**Réf. : GSAC/T 50/05**
**Date : 08/09/2005**
**Nb de pages : 3**
**EMERGENCY AIRWORTHINESS DIRECTIVE (CNU) PUBLISHED BY DIRECTION GENERALE DE L'AVIATION CIVILE (FRANCE) ON BEHALF OF EASA.**
**THIS TEXT IS NOT SENT TO FOREIGN OPERATORS OF AIRCRAFT NOT REGISTERED IN FRANCE. IT IS UP TO THE NATIONAL AUTHORITIES TO FORWARD IT TO THEM ON RECEIPT.**
**N° UF-2005-160 – ATR – ATR 72 and ATR 42 aircraft**
**OBJET : ATA 28 - Fuel quantity indicator.**
**1. EFFECTIVITY:**

Ref AOM: 42-72/2005/08 issue 5

**SUBJECT: TUNINTER ATR72 ACCIDENT**

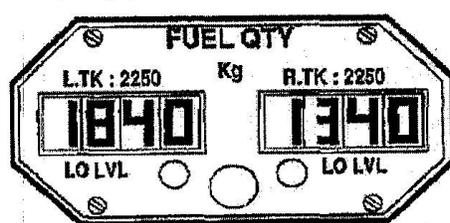
ATR reminds that the Part Number is the primary and unique identification means for any given equipment in conjunction with the IPC effectivity. The part number is indicated on the identification plate attached to the equipment.

ATR recommends the operators to check that their fleet configuration related to the Fuel Quantity Indicators (3QT) is compliant with the one provided within their applicable Illustrated Part Catalog on section 28-42-80-01.

ATR 42 FQI in kg

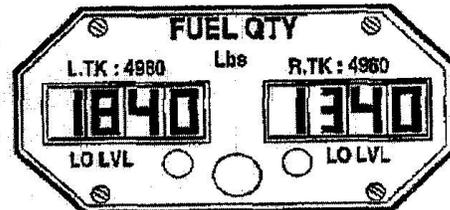
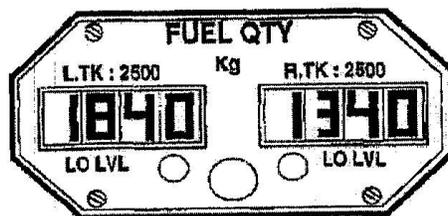
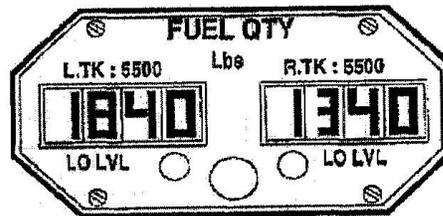
Furthermore, the ATR42 and ATR72 indicators exhibit different front sides where the maximum fuel capacity per tank is indicated either in kilograms or pounds of fuel.
